Subject: **SCPPA'S PRE-HEARING CONFERENCE STATEMENT &
TESTIMONY PACKAGE
DOCKET NO. (07-AFC-9)**

Application for Certification for the
CANYON POWER PLANT

DOCKET NO: 07-AFC-9

**SOUTHERN CALIFORNIA PUBLIC
POWER AUTHORITY'S PREHEARING
CONFERENCE STATEMENT**

CANYON POWER PLANT
 GENERAL ARRANGEMENT
 PLANT ISLAND

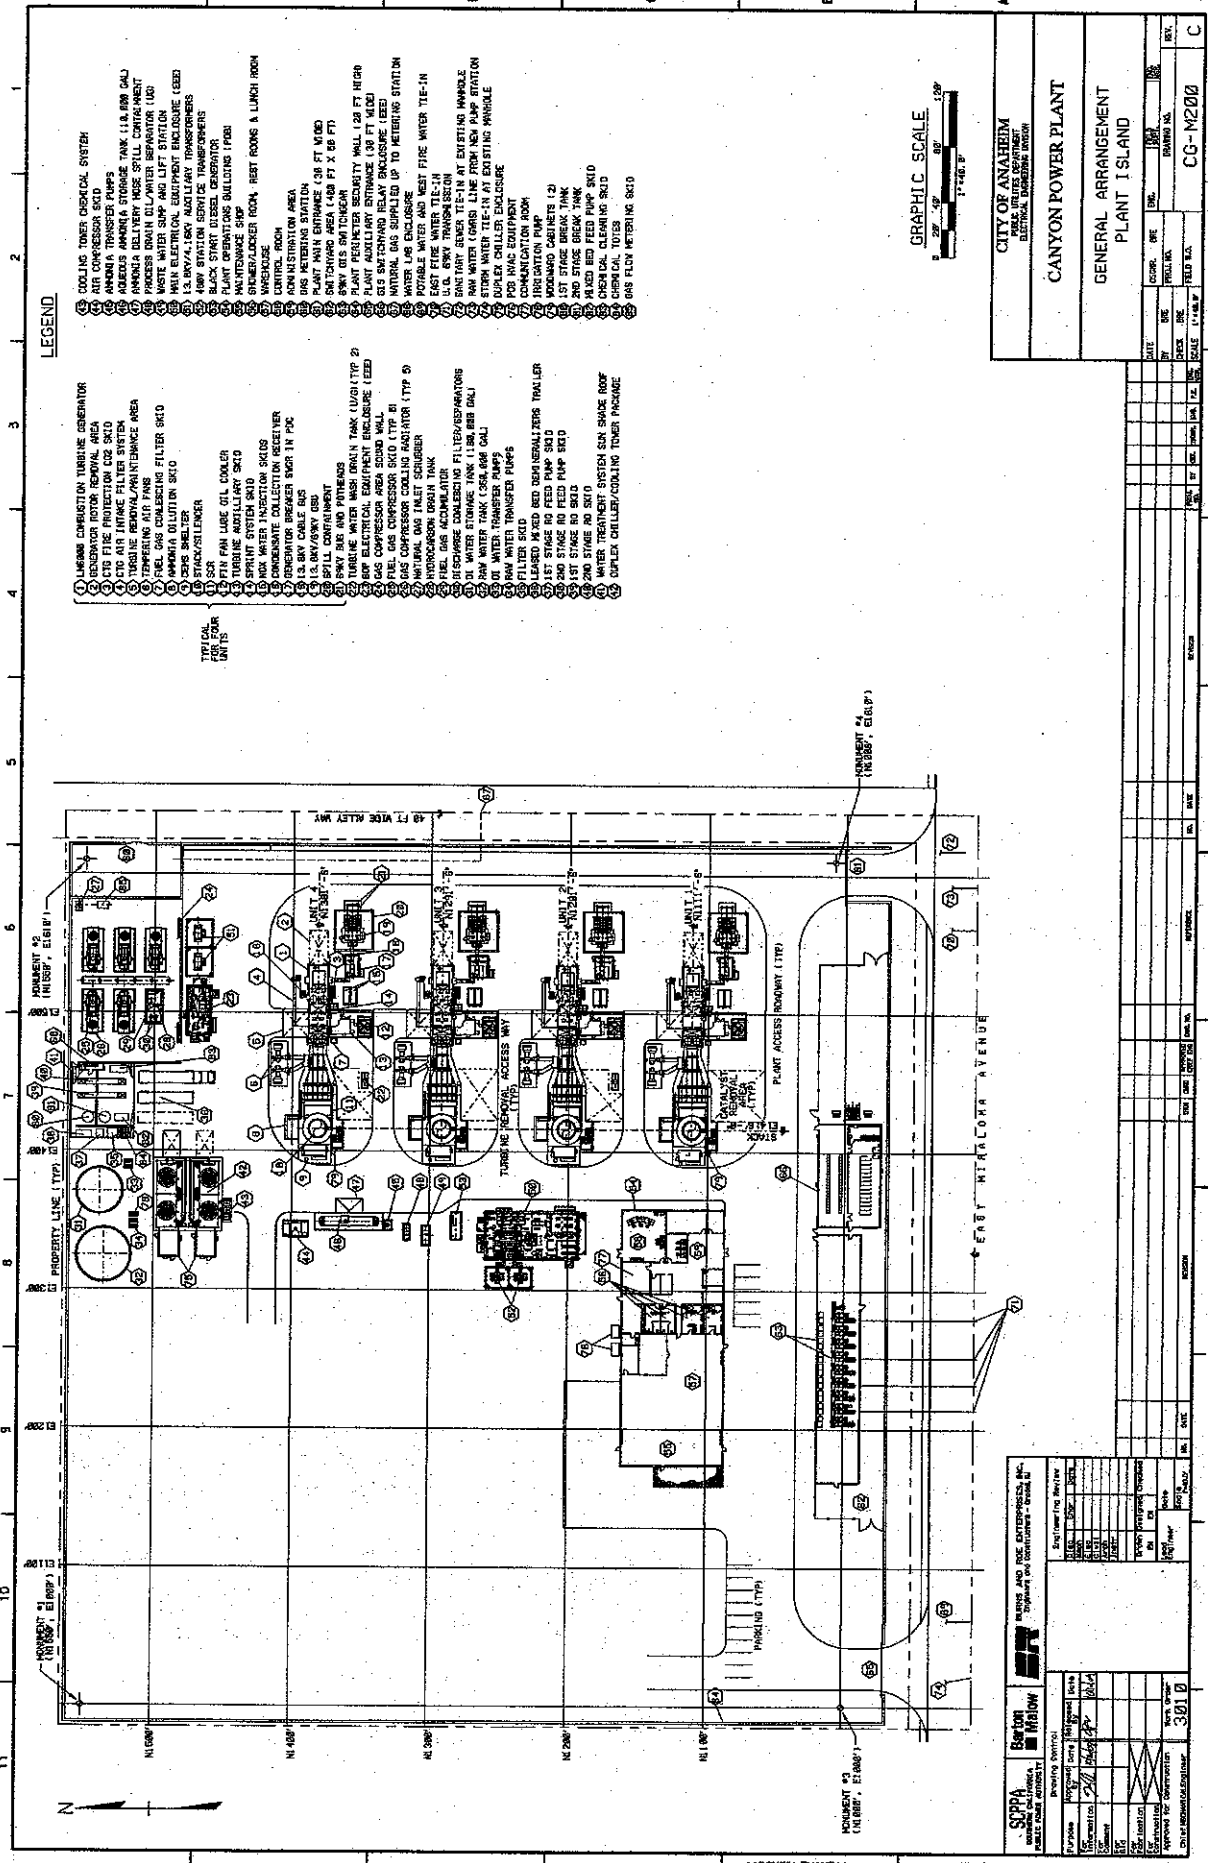
Item 2 lists inlet air evaporative coolers. This description should be modified to read, "Combustion Turbine Generator inlet chillers".

The PSA identifies that CO will be controlled to 6 ppm. This should be corrected to 4 ppm.

The second paragraph describes the wastewater streams and incorrectly identifies that certain streams will be directed to the oil water separator. Only oily wastewater will be directed to the oil water separator. Blowdown from the chiller, reject water from reverse osmosis and domestic sanitary wastewater does not contain oil and therefore will not be directed to the oil water separator. Therefore, we recommend that the description be modified accordingly.
